**Department of Energy**

February 24, 1998

**DOE's Response to Comments  
Made by EEG to Docket A-93-02, dated 12/31/97**

## EEG Comment #1: Solubility - FMT Model and the database

**Figure 1.** Aqueous concentrations in 0.0018- $\mu\text{m}$  filtrates from nonphosphate-glass/water suspensions equilibrated under  $\text{Ar}(\text{g})$  atmosphere. The solid line represents predicted solubility of  $\text{Nd}(\text{OH})_3 (\text{gl})$

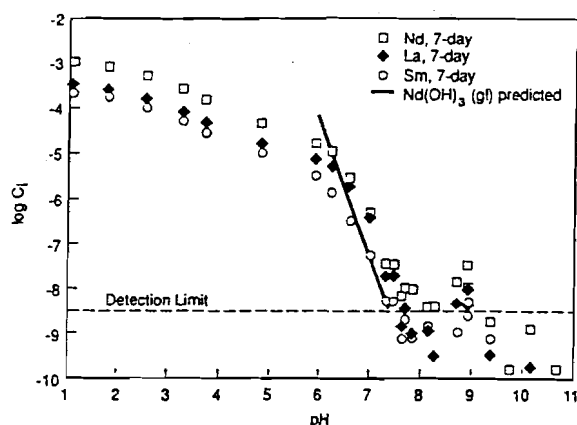
Plutonium will account for 82% of the WIPP radioactive inventory 100 years after closure. The CCA maintains that the plutonium will exist either as Pu(III) or Pu(IV). However, the plutonium data were not used for developing the FMT model to predict the solubility of Pu(IV). Rather, the CCA relied on data for uranium and thorium as analogs. But there are long recognized concerns about relying entirely on the oxidation state analogy to derive thermodynamic constants for modeling complex electrolyte systems. As stated in the NAS/NRC WIPP Committee report (Oct. 1996, p. 129):

The trend for the analogous lanthanides in the same oxidation state to exhibit similar behaviors is further borne out by experimental results, as shown in Figure 1<sup>3</sup>.

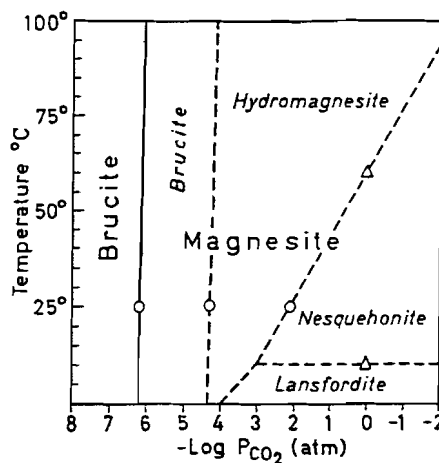
Perhaps the most important questionable assumption made in projecting the solubility values used in the CCA and the PAVT is the presence of hydromagnesite as the dominant stable mineral species resulting from the MgO backfill. DOE's experimental efforts with MgO predominantly produced nesquehonite, a magnesium carbonate mineral with the later appearance of an unidentified phase. Hydromagnesite was not formed in the experiments reported by the DOE (Van Bynum's 4/23/97 report); a hydromagnesite-like unnamed mineral is reported. The chemical structure of this mineral is in fact more like nesquehonite. The DOE and the EPA believe that "hydromagnesite will be the metastable hydrated magnesium carbonate phase and nesquehonite will be an intermediate phase." (EPA Technical Support Document III-B-17, p.2). There is no experimental data for the length of time that nesquehonite is expected to exist. The distinction between the projected hydromagnesite-dominated or nesquehonite-dominated chemical environment in the repository is important because the actinide solubilities in the presence of nesquehonite are 3 to 4 orders of magnitude higher than in the presence of hydromagnesite.

The choice of magnesium-carbonate mineral phase to constrain equilibrium calculations is clearly shown in the MgO-CO<sub>2</sub>-H<sub>2</sub>O phase diagram published in Dr. Friedrich Lippmann's definitive treatise on carbonate mineralogy (1973). As illustrated in Lippmann's figure, the only thermodynamically stable magnesium carbonate mineral in the MgO-CO<sub>2</sub>-H<sub>2</sub>O system is magnesite (Figure 1). Because of strongly held waters-of-hydration, water tends to be incorporated along with the magnesium cation into the structure of magnesium carbonate minerals. As a result, magnesium carbonate minerals formed at temperatures near 25°C tend to be hydrated forms. At earth-surface temperatures, maturation of hydrated magnesium carbonate minerals to the anhydrous form, magnesite, is slow. For actinide solubility calculations, we have elected to use a metastable hydrated magnesium carbonate mineral as the equilibrium-constraining MgCO<sub>3</sub> phase.

As CO<sub>2</sub> is generated, the partial pressure of CO<sub>2</sub> (pCO<sub>2</sub>) will begin to increase. On the phase diagram (Figure 1), the reaction path, therefore, begins at 25°C at the left, and moves isothermally to the right. Brucite is present in the system. The pCO<sub>2</sub> continues to increase until the hydromagnesite-brucite join is met, at approximately 10<sup>-4.2</sup> atm pCO<sub>2</sub> (Figure 1). That point on the phase diagram is the invariant point. Because the moles of emplaced MgO exceeds the maximum possible amount of CO<sub>2</sub> generated by a factor of nearly four, the phase diagram shows that nesquehonite will never be produced in the WIPP.

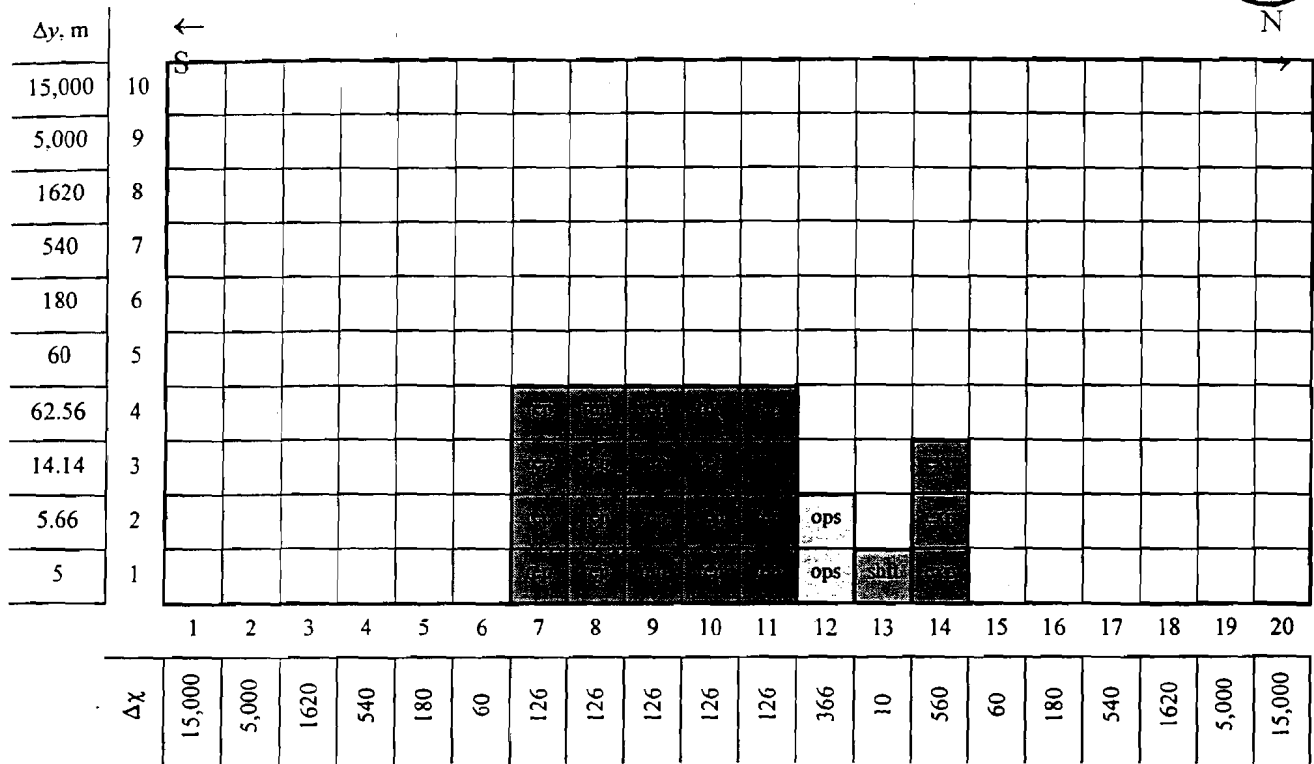
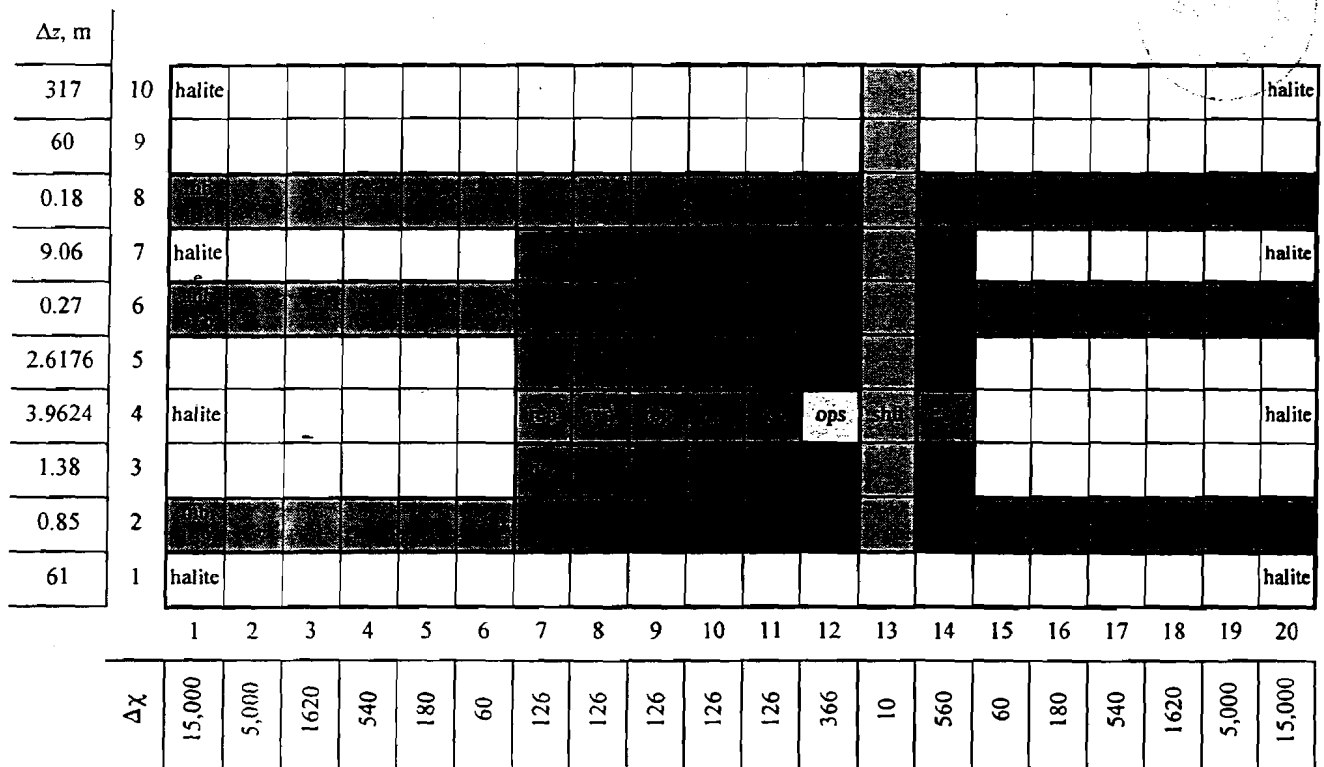
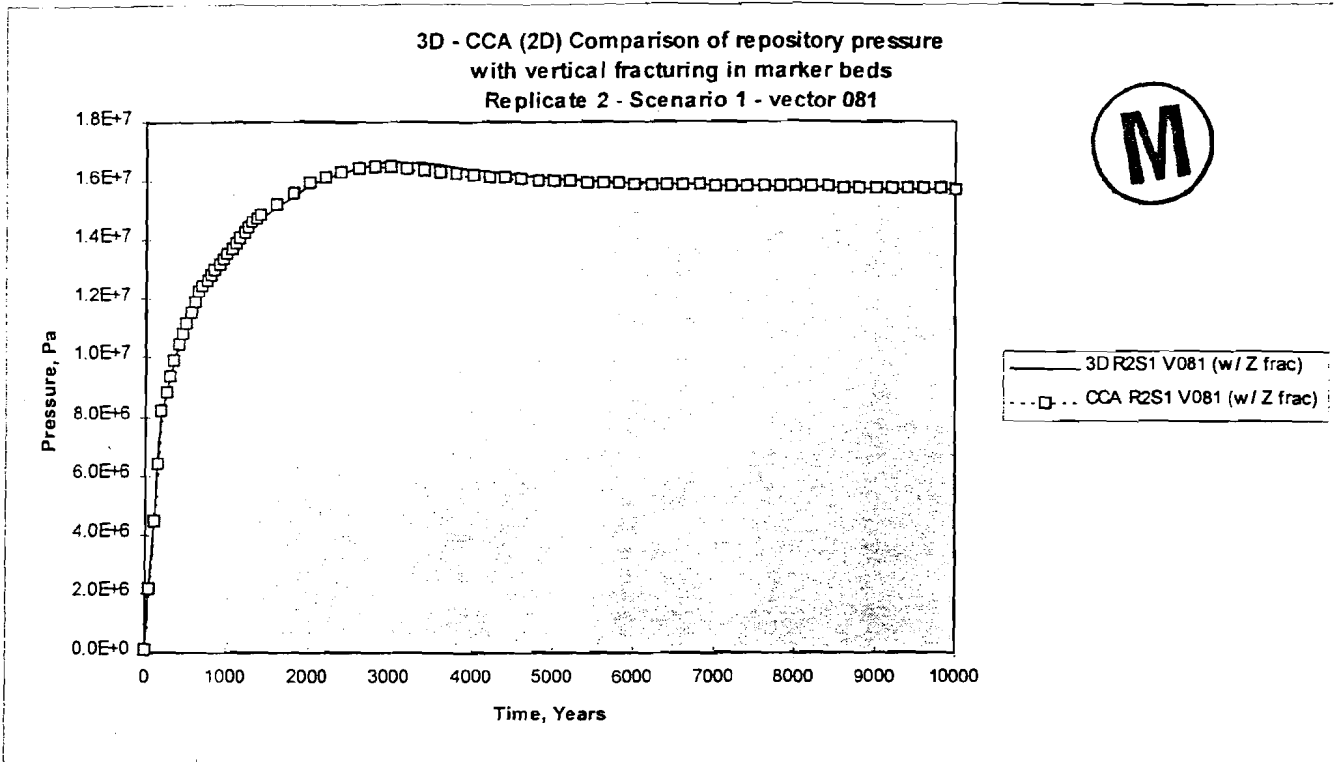
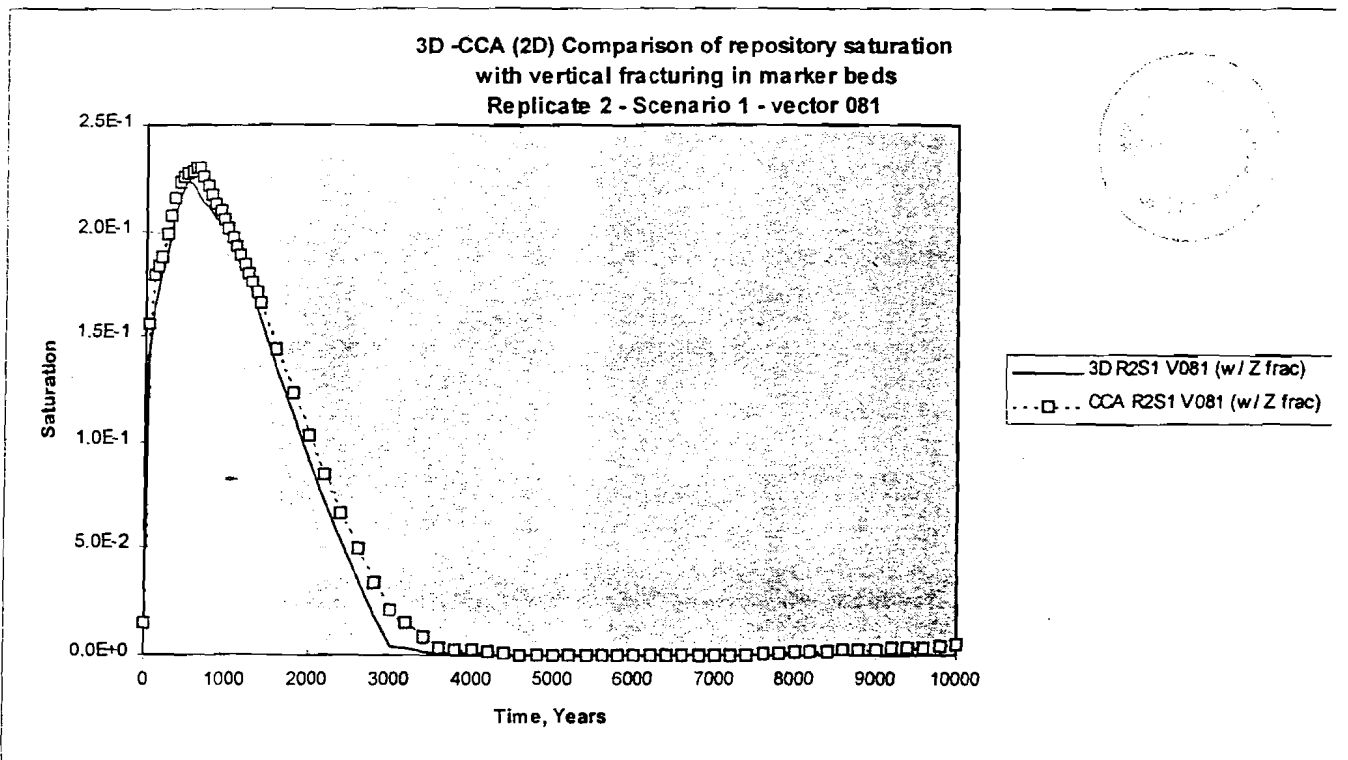
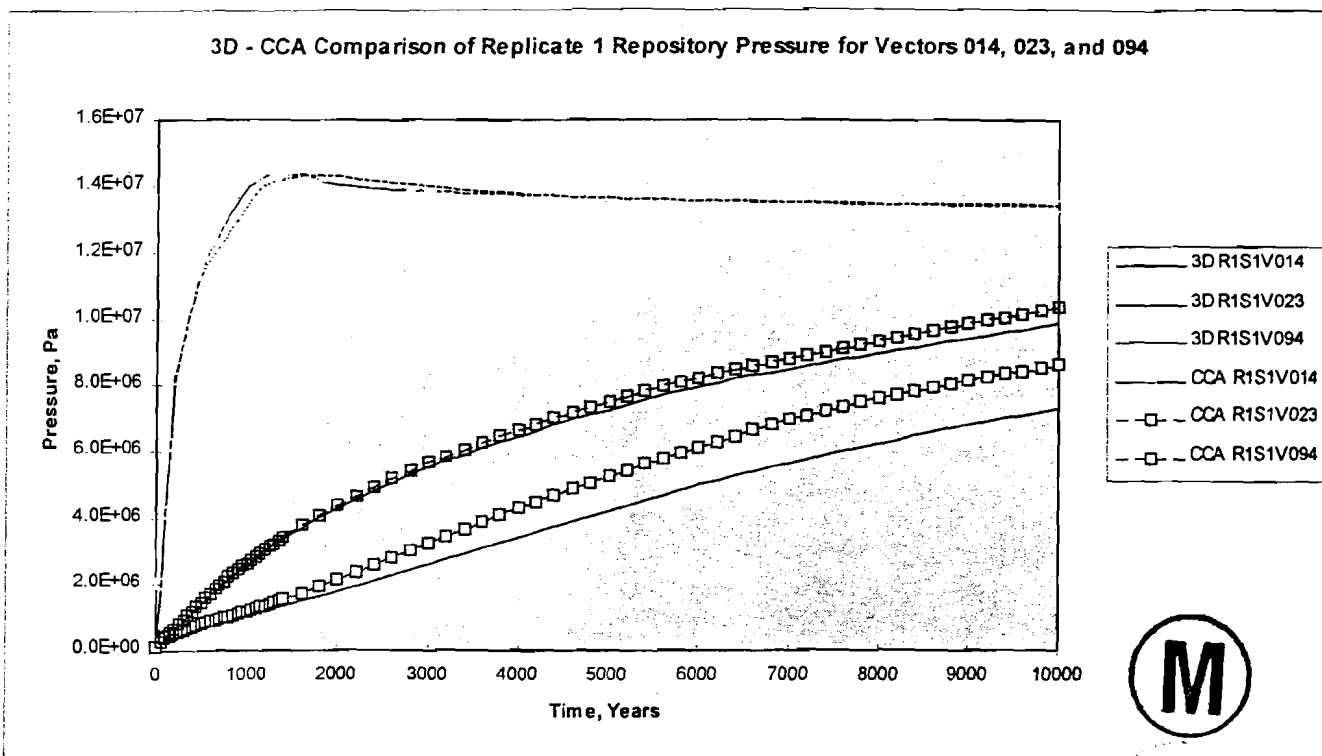
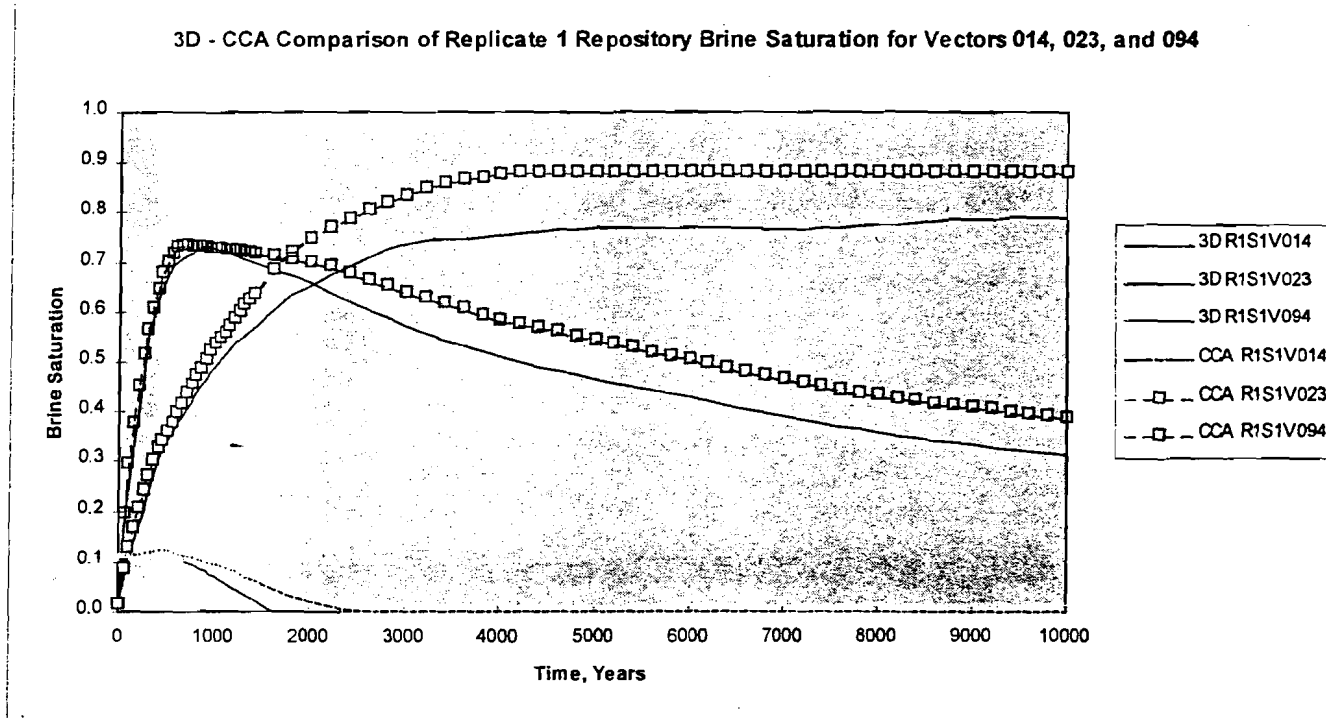
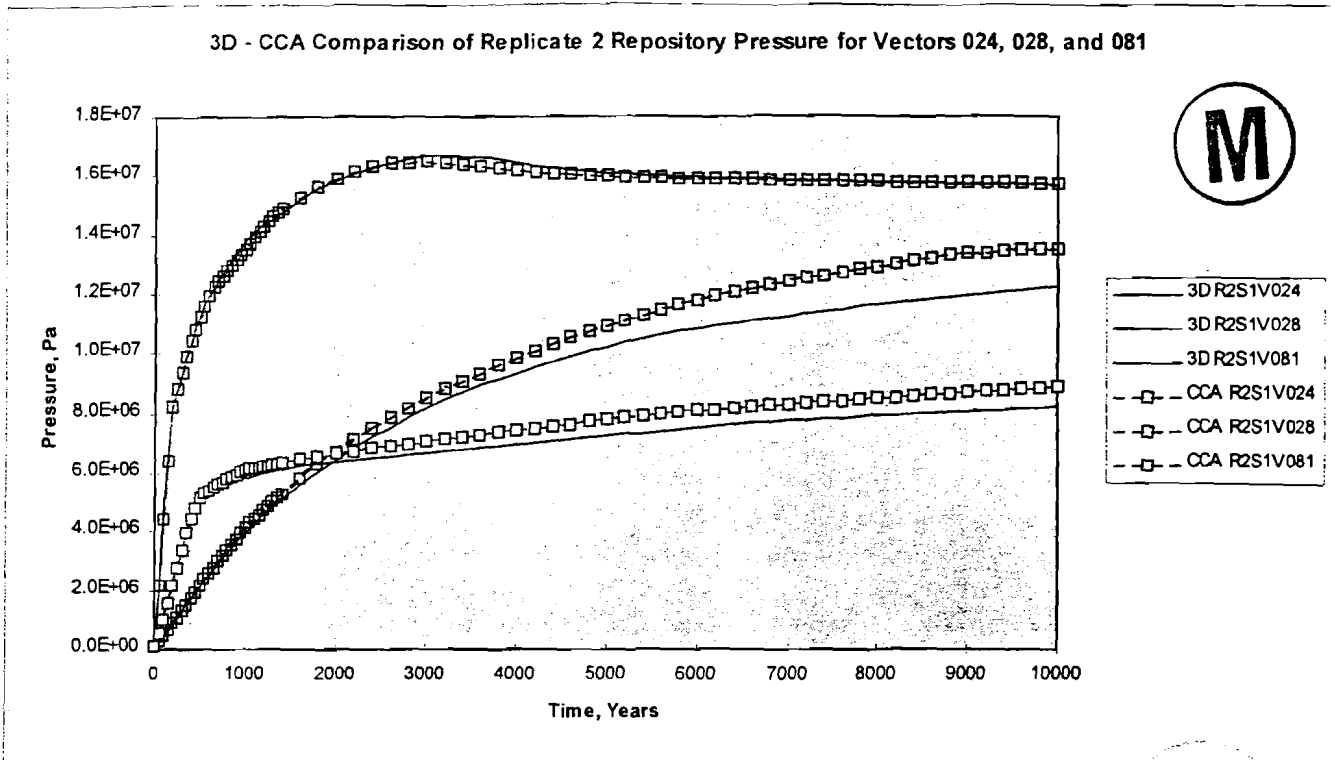
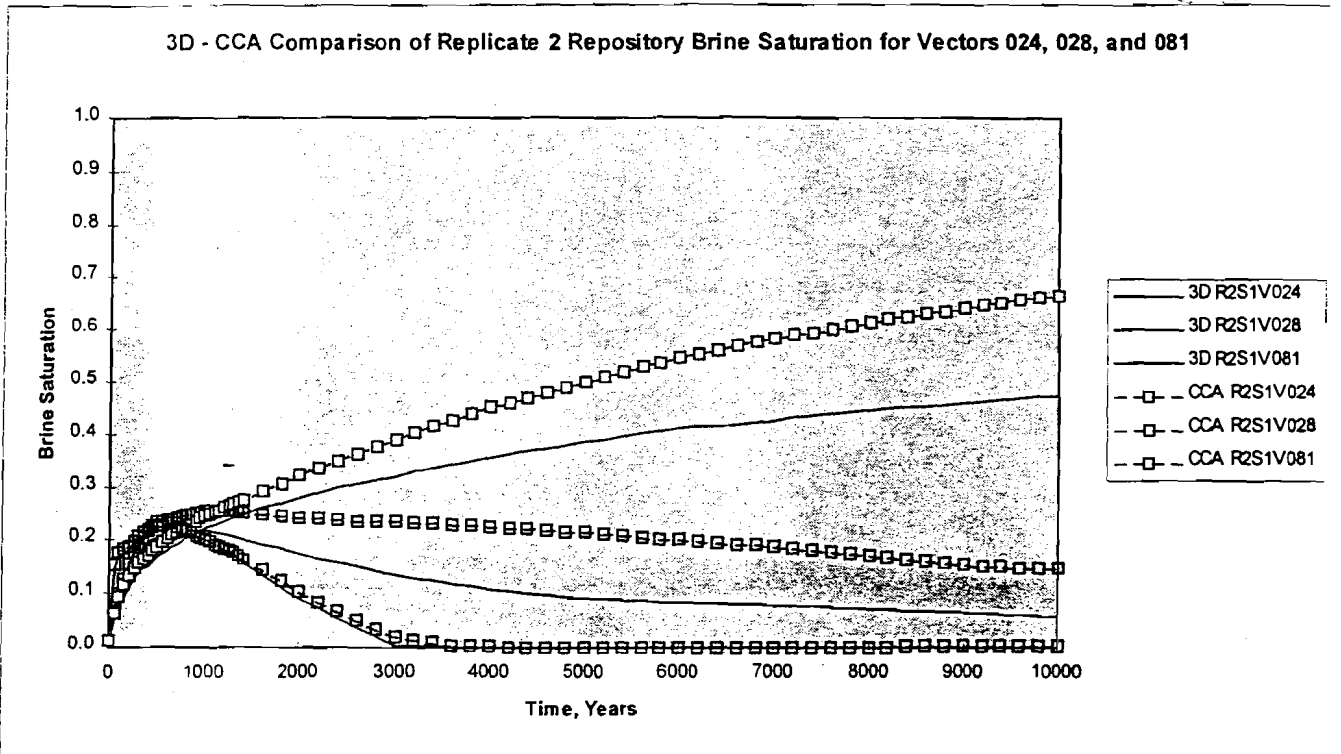
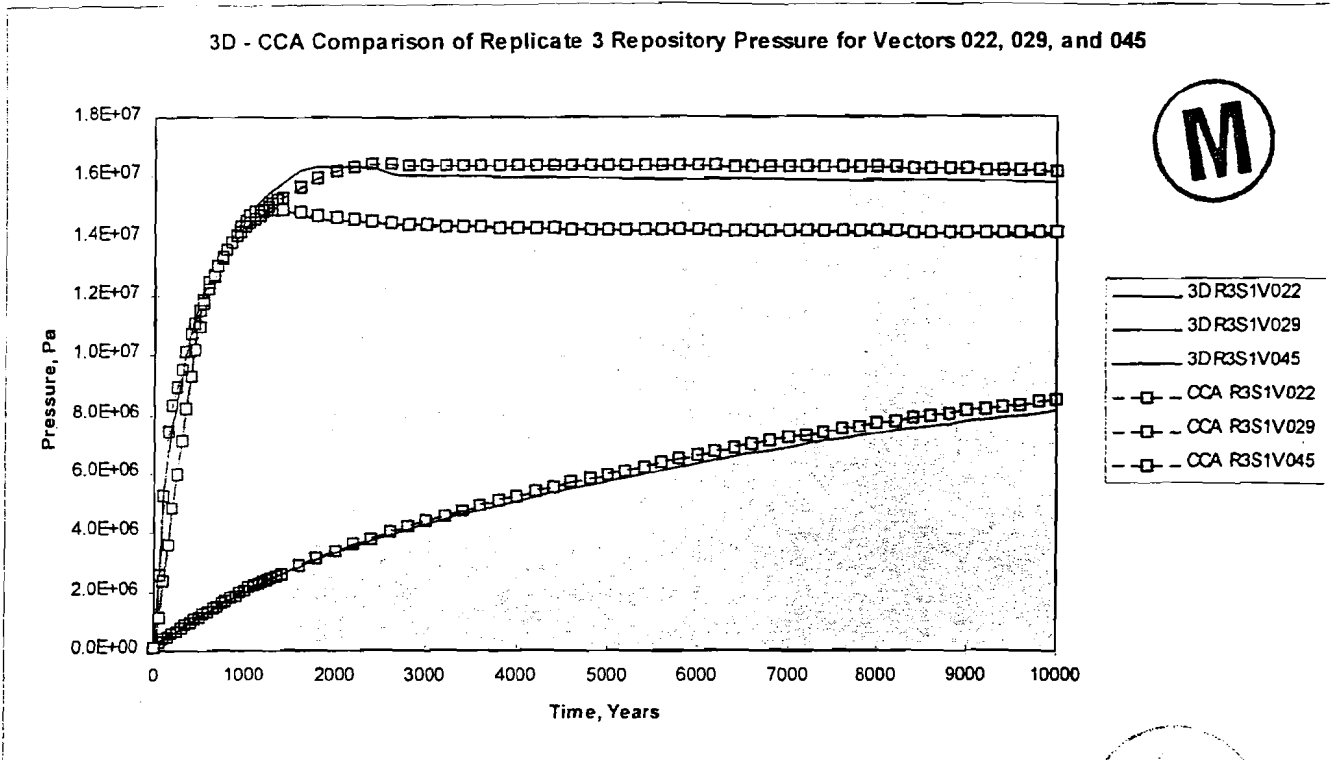
To resolve this issue, the EEG recommends that several 3D BRAGFLO simulations of the repository should be performed using the parameter values of vectors used in the CCA performance assessment. The 3D BRAGFLO simulations should be used to provide repository conditions for the normal suite of direct brine release calculations. The calculations should also be assessed in terms of impact on spillings calculations. Spallings simulations are probably not required to assess the impact. The following criteria may be used to select the CCA vectors for running the 3D simulations to bound the magnitude of the problem:

- Direct brine release calculations should be sensitive to increased brine saturations above the waste residual brine saturation. Vectors that had either large brine saturations or a mobile brine component (saturations above the residual saturation) are more likely to be sensitive to increased brine inflow. Figure 5.1.5 of the preliminary sensitivity analysis report (Helton, 1996) indicates one vector with a 10,000 year pressure above 14 MPa and a brine saturation above 0.4. This is a likely candidate.

- If the first simulations indicate a large change in saturation, then assess whether the 3D BRAGFLO simulations indicate a much larger number of significant direct brine releases than those calculated in the CCA. Simulations using brine saturations on the order of 0.1 and 0.3 should be performed.

Additionally, more complex supplementary 3D calculations were performed in concert with EEG's recommendations made during discussions with EEG at a January 17, 1998 meeting (Vaughn, Bean, Schreiber and Dotson, 1998). These results collectively show that the 2D geometry used by BRAGFLO in the 1996 CCA performance assessment calculations is appropriate and does not result in an underestimate of direct release during human intrusion. In all cases investigated (10 simulations using 9 CCA realizations) the 2D simulations consistently predict either the same or larger repository pressure and brine saturation than their 3D counterparts. Both larger pressure and brine saturation in the repository at the time of intrusion would lead to larger releases. Thus, the 2D geometry results in a conservative estimate of the releases when compared to results from a 3D representation. These calculations are also reproduced in Attachment 1.

In figures 5 through 10 the repository pressure and the brine saturation resulting from an additional 8 simulations are compared between the 2-D CCA simulation and their 3-D counterparts. The characteristics leading to the selection of these additional realizations are outlined in an earlier section. Vertical fracturing is disabled in the 3-D simulations as justified in Attachment 1. Both the pressure and brine saturation in the 2-D version are either nearly the same or slightly larger than their 3-D counterparts. Since larger pressure and higher brine saturation result in larger releases during drilling, everything else being equal, the 2-D geometry used by BRAGFLO for the CCA calculations leads to a conservative (larger) estimate of release than the 3-D representation.
